# Access Compliance Report

## Public Rights-of-Way

### (Curb Ramps)

Intersection ID: 17042	Main Street: BUCKNELL_AV	Cross Street: QUEENS_RD_EAST	Location: N
ADA ID: 74F6D8A8C970	Ramp Type: Directional1	Initial Pass/Fail: Fail	Overall Compliance: No
Codes/Mitigation Info/Possible Solution		Field Measurements/Component Compliance

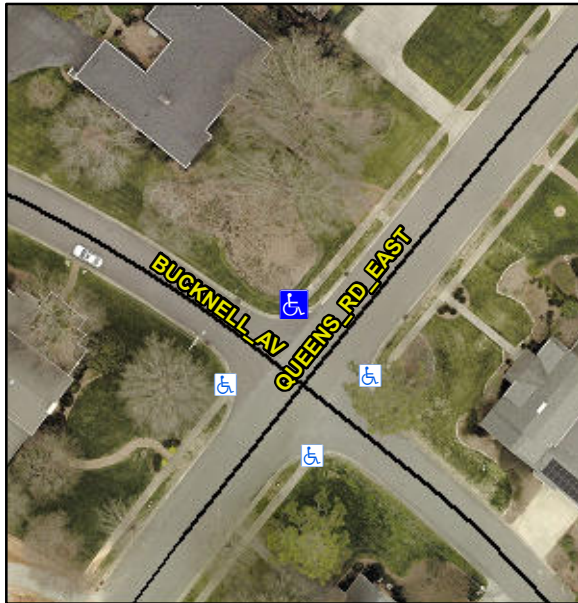
**NO CURB LINE**

**R304.2.2, R304.5.3**

**Remove & Replace Entire Ramp.**
